AREA FOR ARCHITECT/G.C. APPROVAL STAMPS AND COMMENTS

OPUS CENTER @
ROCKSPRING
PARK, BETHESDA
MARYLAND

FABRICATION RELEASE:
THE PANEL DIMENSIONS HAVE BEEN REVIEWED AND
APPROVED AS NOTED ON THIS DRAWING. THE
PANELS ARE HEREBY RELEASED FOR FABRICATION

LAYOUT FOR ELEVATIONS "D", "E", "F" AND "G"

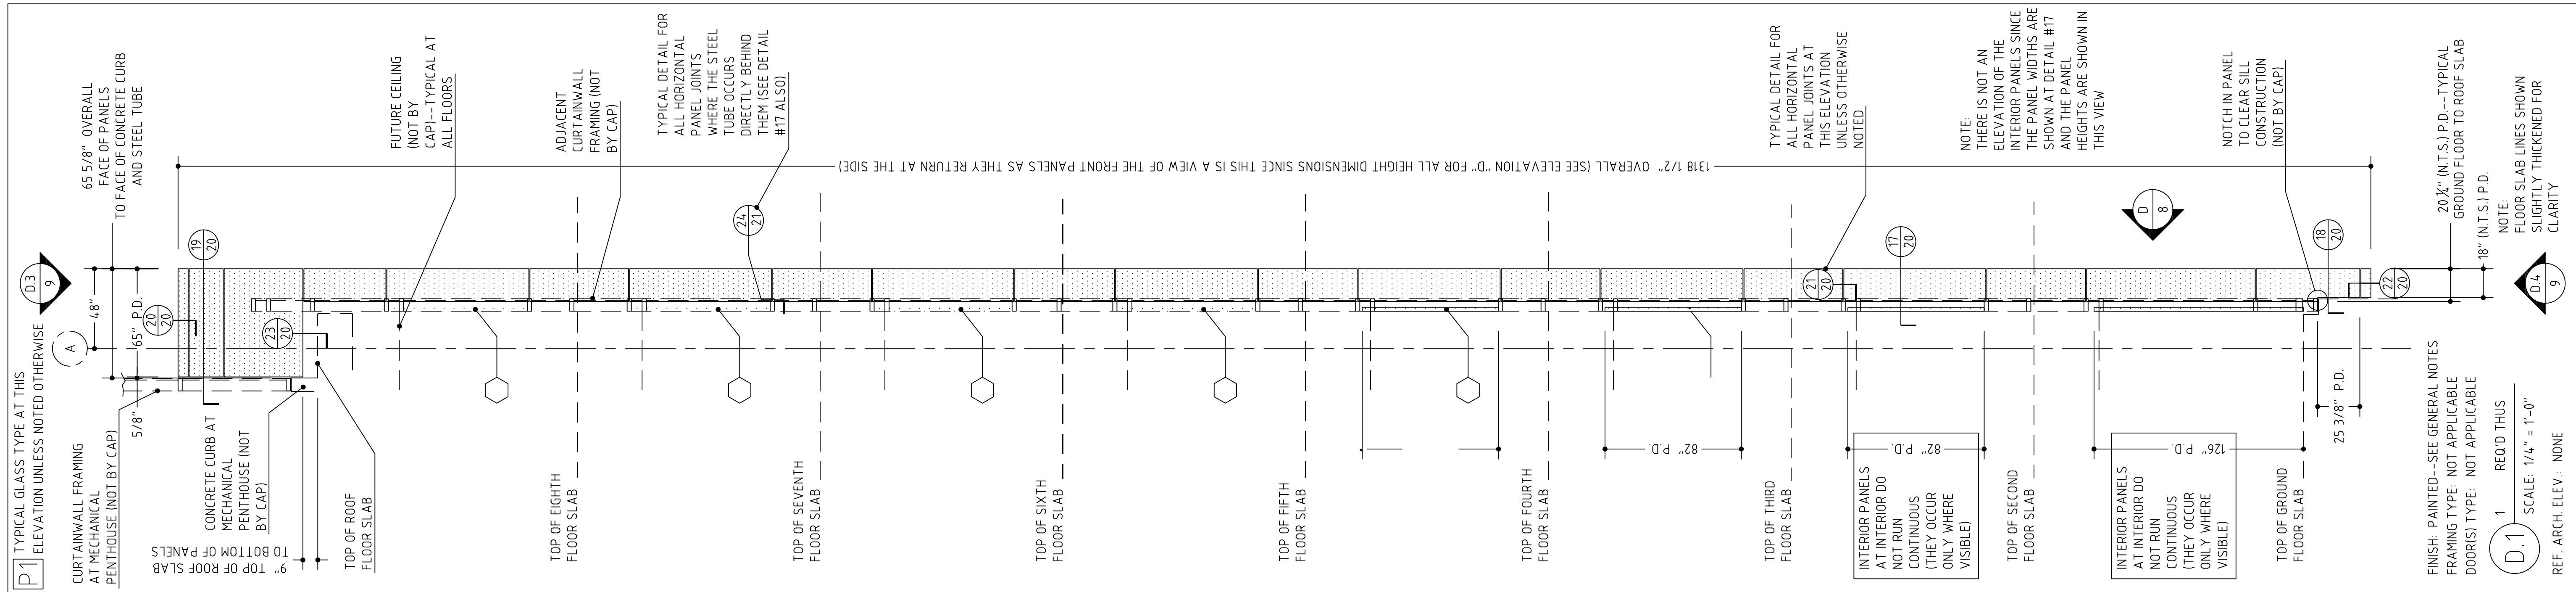
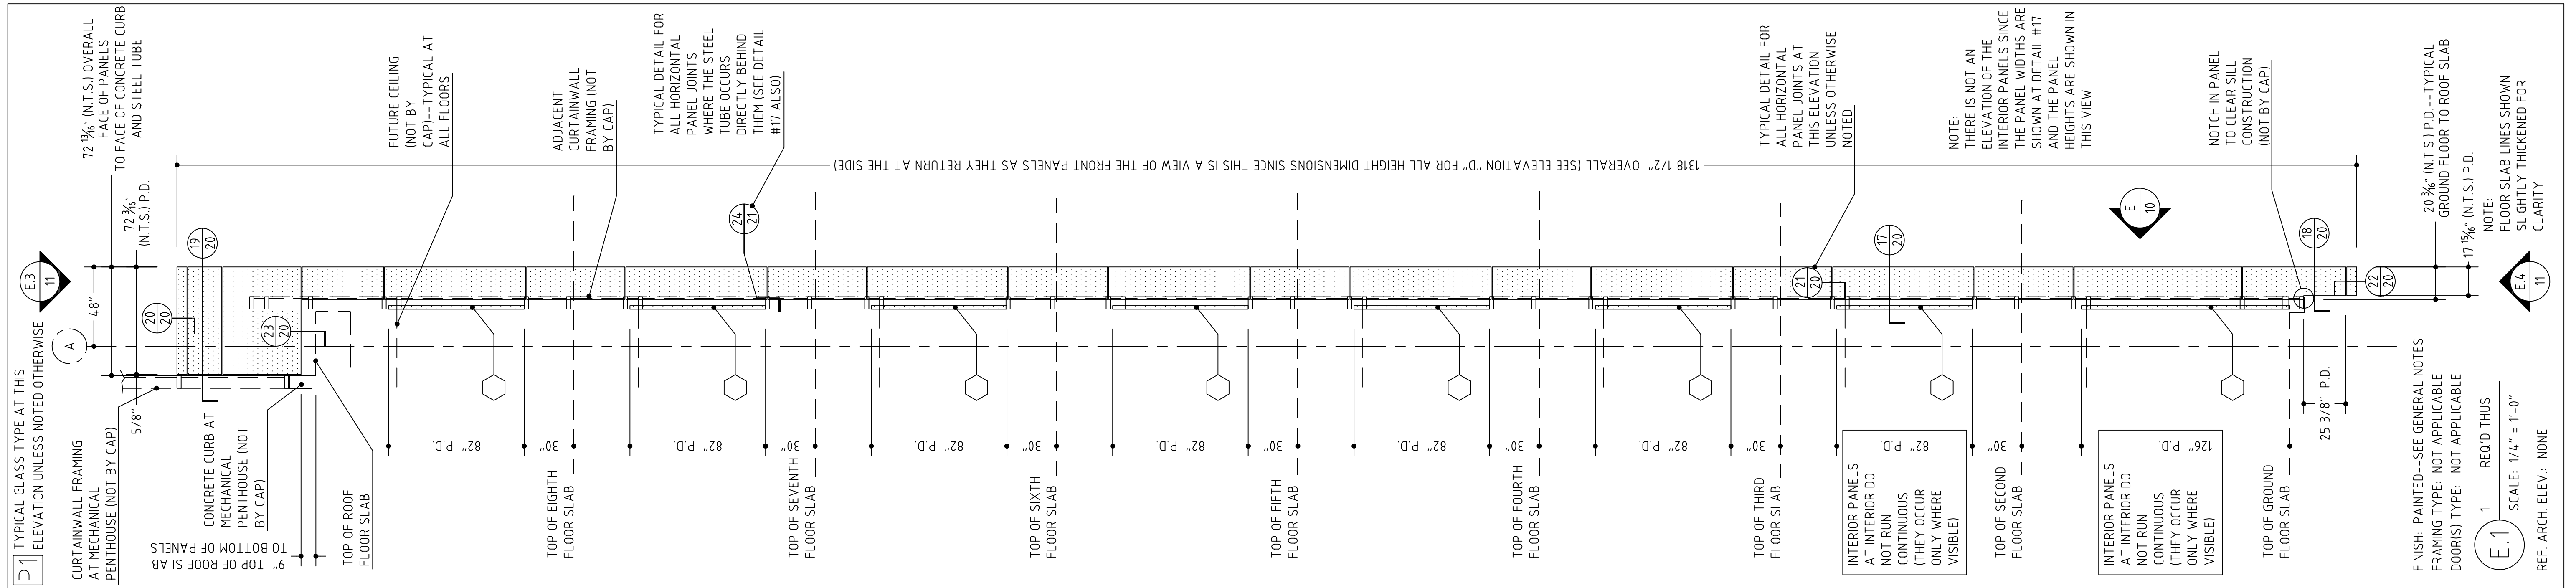
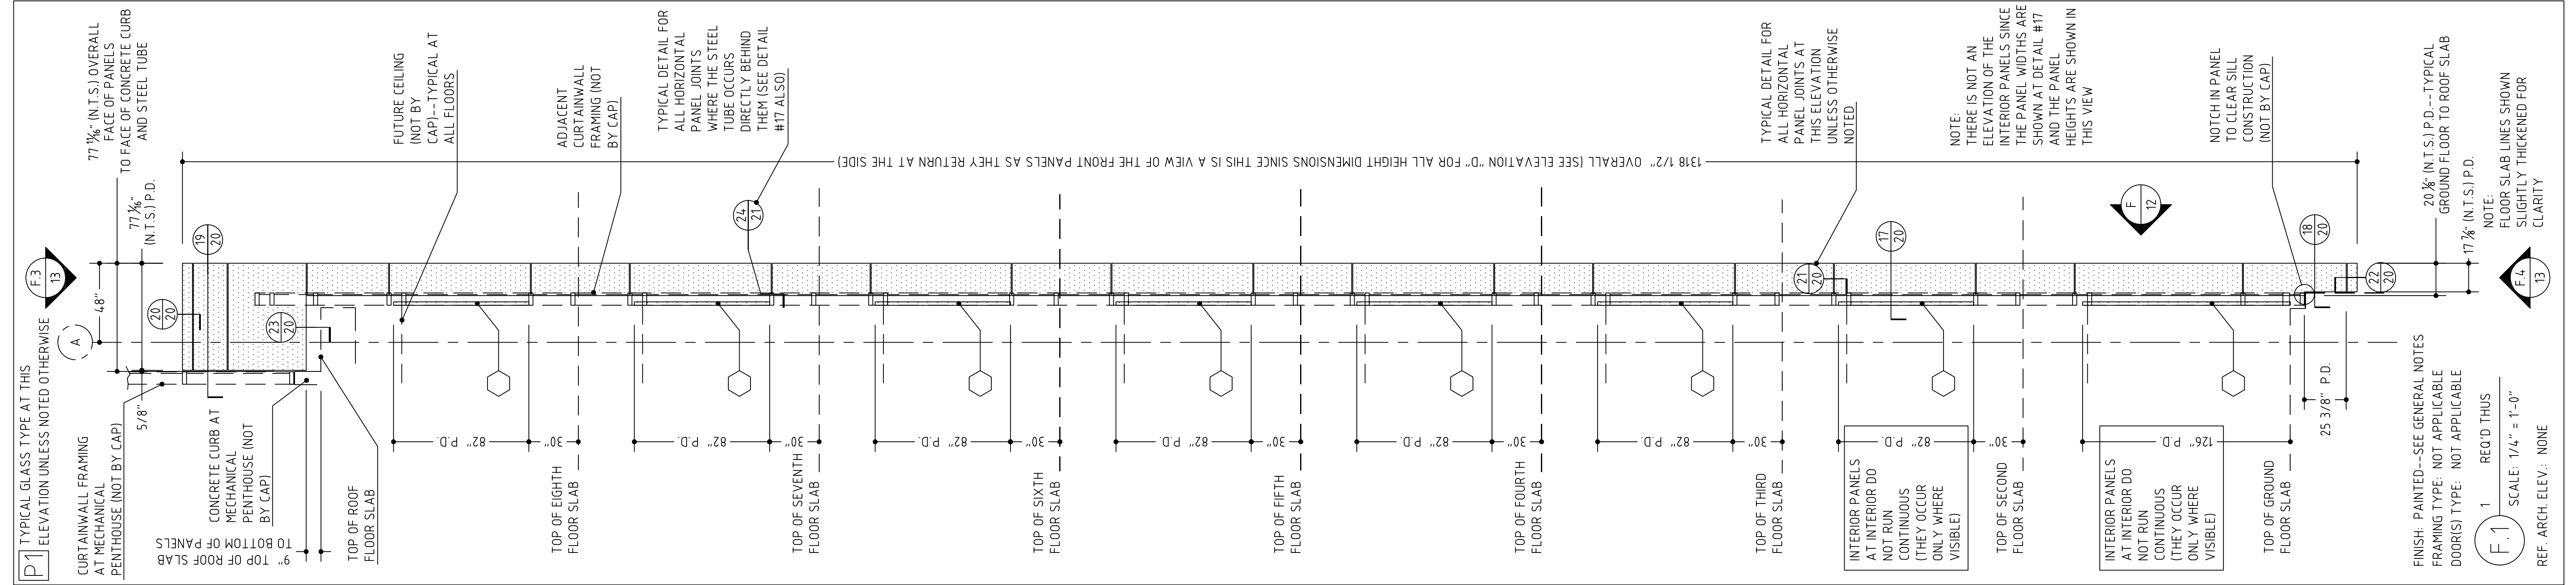
UNFORMED PANEL
WIDTHS FOR THE PANEL
"FINS" MUST NOT EXCEED
50" (NOTE-SOME PANELS
ARE ROTATED TO
COMPLY WITH THIS)
